Proposed Plan Change 7 Submission

Chapter 3 – Structure Plans

3.6 – Rotokauri Structure Plan

Figure 15-7a

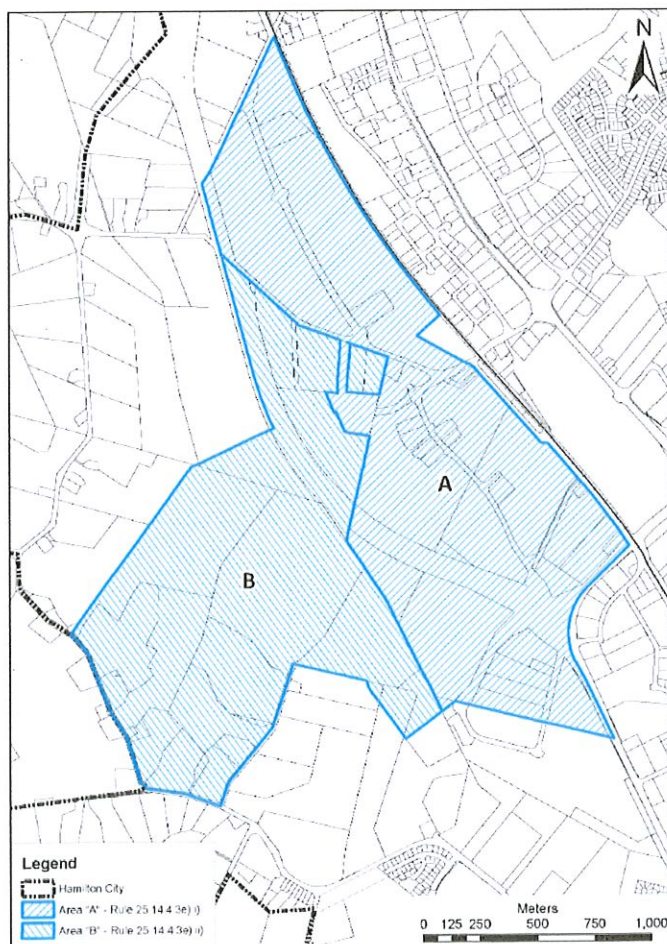
The proposed plan change is inconsistent with structure plan component “3.6.3.2 Roothing” in its entirety. The proposed area is within the stage 2 area, outside of Areas A and B (see Figure 15-7a). The Rotokauri Structure Plan indicates that the release of land beyond stage 1A (such as the PPC):

Proposals for the development of land in 'Area B' on Figure 15-7a will require careful scrutiny to ensure that adequate network capacity exists to support the development, or will be provided as part of the development and they will not compromise the development of land in 'Area A' on Figure 15-7a. Development will require:

e) The development of land outside Areas 'A' and 'B' (Figure 15-7a) will need to coincide with the northwards extension of Rotokauri Minor Arterial Road to connect with Te Kowhai Road at the City Boundary.

The PPC is clearly contrary to these provisions, and the developer is trying to dodge the full cost of developing ahead of the planned sequencing by exempting itself from these Rotokauri Structure Plan provisions. The PPC does not provide adequate transport network capacity outside of the PPC area to support the proposed development. The proposal does not achieve a sustainable expansion of the city and does not represent coherent and integrated development, because the transportation effects beyond the Rotokauri North boundaries have not been resolved.

- Either decline the private plan change; or
- Decline proposed inclusion of section 3.6 d (exemption of PPC area from Rotokauri Structure Plan), but approve the development subject to requiring the developer to adhere to all existing Rotokauri structure Plan provisions, including:
 - a) requiring they construct the Rotokauri Minor Arterial Road;
 - b) provide an ITA that adequately assesses impacts on the wider transport network;
 - c) cater for the demand generated within the wider transport network;
 - d) requiring the developer to fund all necessary road network upgrades and additions.
 - e) provide a full economic assessment of the financial impact on the remainder of the Rotokauri Structure plan area and including the likely cost of the required roading upgrades.
